Town of Parker Community Development Department
Development Review Division
Attention: **Amber Wood-Hicken**

Application Type: **Site Plan**
Status: **First Referral**
Application Name: Canvas F1 L2 - Quick Quack Carwash
Case/AP#: **SP24-86**
Referral Received: August 19, 2024
Comments Due: September 16, 2024

Review date: **August 20, 2024**
Plan reviewer: **Randall L. Capra**, rcapra@parkeronline.org
Phone: 303.805.3163

TOWN OF PARKER - FIRE/LIFE SAFETY:	R REVIEWED FOR CODE COMPLIANCE; REVISIONS REQUIRED
---	---

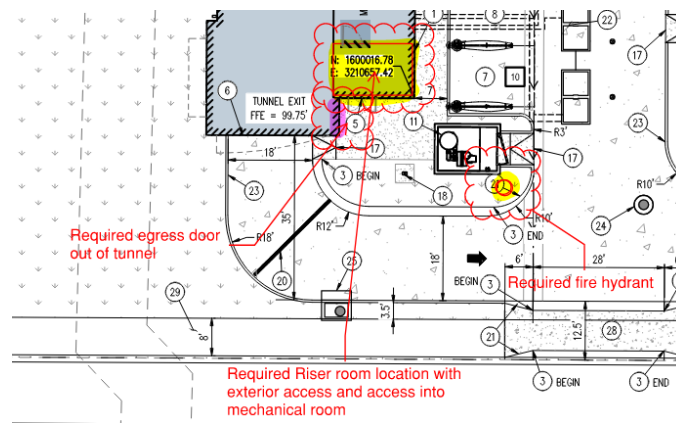
9. The code requires that egress, meeting all components of the code, be provided. EM and EXIT signage shall be provided along with an exterior egress door (bay doors are not egress doors and will not be accepted. See

the site plan above for an acceptable location for the REQUIRED egress door. Address this issue when resubmitting.

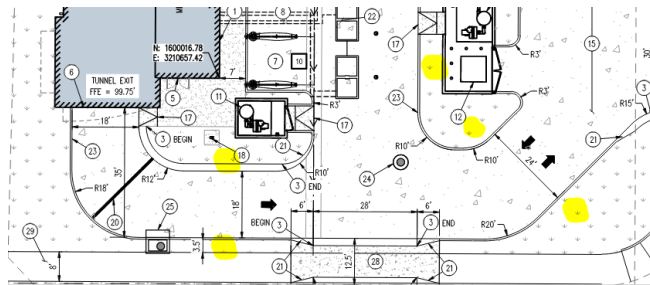
11. The Town of Parker requires that fire apparatus access roads meet the clear-width and weight-bearing standards of the jurisdiction in which the project is located. Roadways shall be designed to support the imposed weight of fire apparatus, 30-ton, two axle and 40-ton three, axle vehicles. An unimpeded clear width of 26-foot shall be always maintained per the requirements of D103.6.1. As such, any location where parked vehicles would obstruct this clear width requirement will require "NO PARKING – FIRE LANE" signage. *This signage shall be red on white. Update design criteria has been provided at the end of this document; ensure compliance when resubmitting. Note – See below for NO PARKING – FIRE LANE signage locations*
